Planning and regulatory committee

Thursday 27 September 2018

Schedule of Updates

182314 - SUMMARY DESCRIPTION (FOR FULL DESCRIPTION SEE APPLICATION FORM AND PLANNING CASE STATEMENT): • PROPOSED NEW FIELD ACCESSES • PROPOSED MAINTENANCE TRACKS TO SERVE SOUTHERN LINK ROAD (APPLICATION 151314) AT MULTIPLE PARCELS OF AGRICULTURAL LAND, SOUTHERN LINK ROAD CORRIDOR (151314) A465 - A49, HEREFORDSHIRE

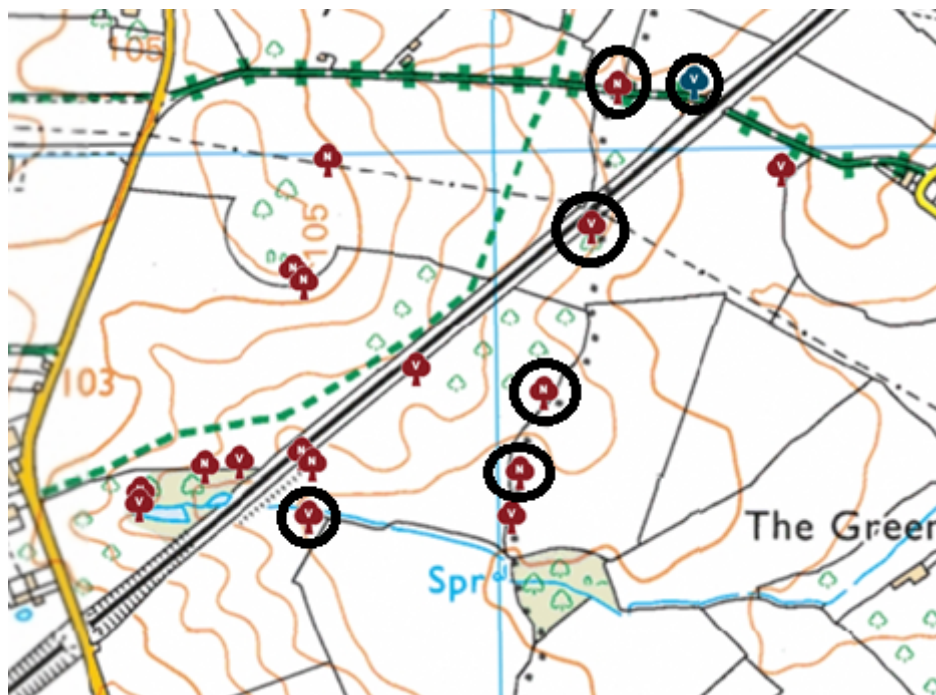
The Woodland Trust **objects** to this application on the basis of damage and potential future loss of a number of veteran trees. Many of these trees are designated on the Ancient Tree Inventory (ATI) with the following details:

These trees can be identified on the Ancient Tree Inventory via the links I have included above. If mapped against the proposed plans these trees can be identified, I have circled them below for you.

While the proposals do not require the removal of any veteran trees, there are elements of the application that would encroach within the canopies and root protection areas (RPAs) of these specimens, specifically temporary haul route alignments and the realignment of a cycle track and its associated fence line. Development within the RPAs and/or canopy of a veteran tree can result in adverse impacts on the tree by damaging the tree's root system through soil compaction and direct root damage, as well as bringing the tree in to a more public setting thereby making it a potential hazard and affecting its long-term retention.

Considering the above recommendations are government guidance the Trust considers that the applicant must take this guidance in to account and recalculate the RPAs of any veteran trees within the site boundary to ensure that a buffer of 15 times the stem diameter is being maintained for any veteran trees. At present it is clear that the veteran trees within the site boundary have not been afforded suitable RPAs thereby contravening national planning policy and government guidance.

Considering the above, the Trust requests that the applicant revisits their Arboricultural Method Statement to ensure that all veteran trees within their site boundary are afforded appropriate RPAs/buffers equal to at least 15 times their stem diameters. Development should not encroach on the RPAs of any veteran or notable trees. Where haul routes/cycle routes are temporarily realigned within the RPAs of veteran trees the applicant must look at rerouting these elements of the development to ensure that the RPAs of any veteran or notable trees are respected and not encroached on. Subjecting veteran trees to damage on account of a temporary development is wholly inappropriate.

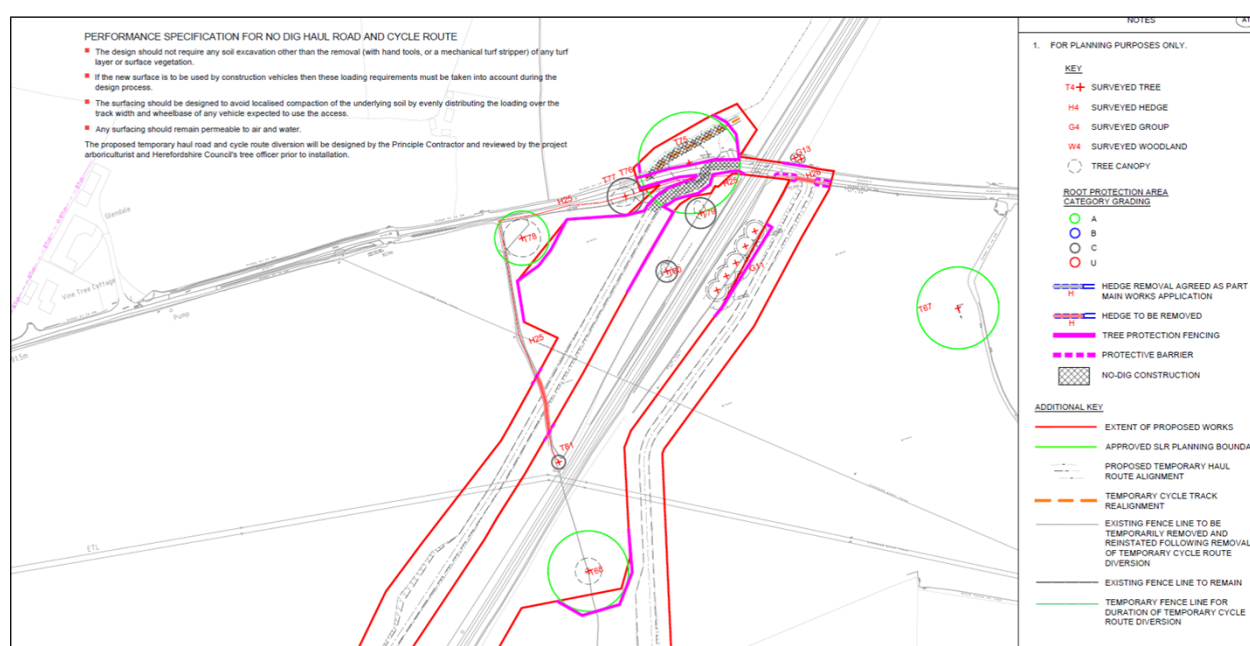
As members will see from the above correspondence, the Woodland Trust has raised concern about the assessment and impact on a number of trees affected by the temporary Haul route and temporary cycle route.

Central to this issue is whether the trees are, in fact, veteran trees.

The arboricultural report, submitted by WSP did not identify the trees in question as Veteran, describing them as 'mature'. The applicants have however since confirmed that the root protection area has been calculated within the report and shown in the drawings as though it were a veteran tree. That is, the RPA has been calculated at 15 times the stem diameter not 12, furthermore the tree has been awarded the highest retention category (Category A).

The Council's Tree Officer has very recently visited the site and confirmed that, in his opinion T75 that lies adjacent to the existing bridleway is a Veteran tree. Given the tree's proximity to the existing metalled bridleway (that would be used as the haul route), officers would accept that the mitigation proposed is acceptable. However, as a precaution, and in respect of the embankment required to exit the field onto the bridleway, a condition that includes the submission of a method statement is suggested. In addition, this condition will look at the other trees noted, their route protection areas and method statements for any works / storage within or adjacent to the route protection areas of the trees.

Given the comments received, officers would take a precautionary approach, and advise that it is not possible to confirm, without doubt, that the proposals would not result in the loss or deterioration of the veteran tree as an irreplaceable habitat. The NPPF directs that development should be refused, unless there are wholly exceptional reasons and a suitable compensation strategy exists.

Prior to commencement of any development detailed on drawing number – 3512983BP-WSP-ZO-XX-DR-T-00003-P04 Sheet 3 - a detailed Tree Protection and Mitigation plan shall be submitted to and approved in writing by the Local Planning Authority that shall include, but not be restricted to:

- Accurate plans showing the Root Protection Area
- Construction method statement for both the temporary Haul Road and cycleway
- Mechanism and details of monitoring for any impacts on trees during construction phase
- Detailed method statement for the reinstatement of land post construction phase
- Mechanism and details of monitoring for any impact on trees post construction phase
- Details of storage area for soil and method statement for soil storage within or adjacent to the Root Protection Areas.
